MIL-B-49450/8(ER)
AMENDMENT 3
3 September 1992
SUPERSEDING
AMENDMENT 2
23 July 1992

MILITARY SPECIFICATION SHEET

BATTERY, RECHARGEABLE, NICKEL-CADMIUM, VENTED, AIRCRAFT
BB-716/A

PAGE 3

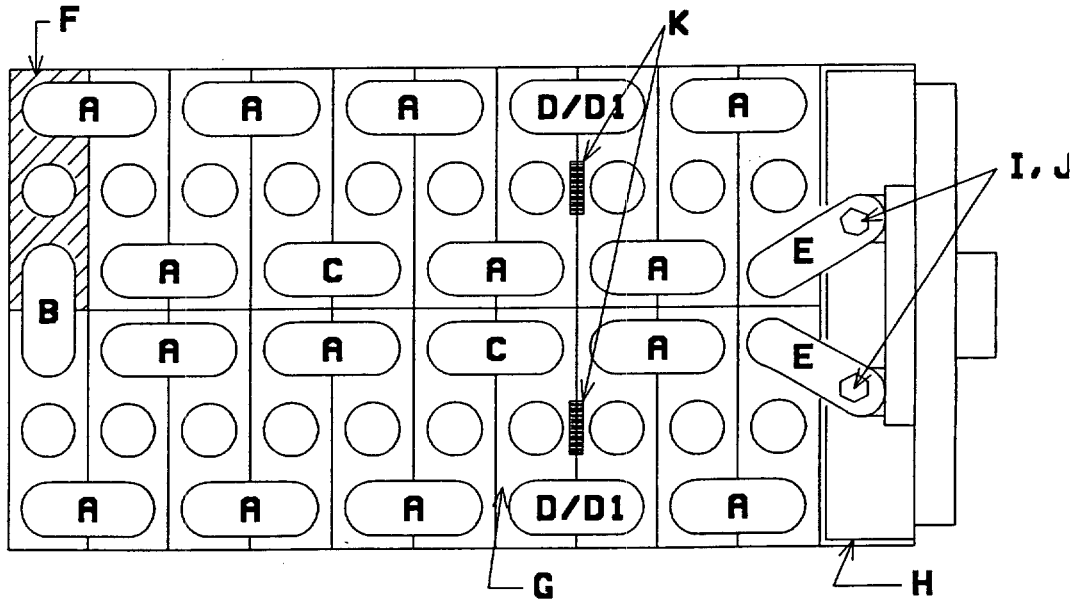
* Delete Figure 3 and substitute the following:
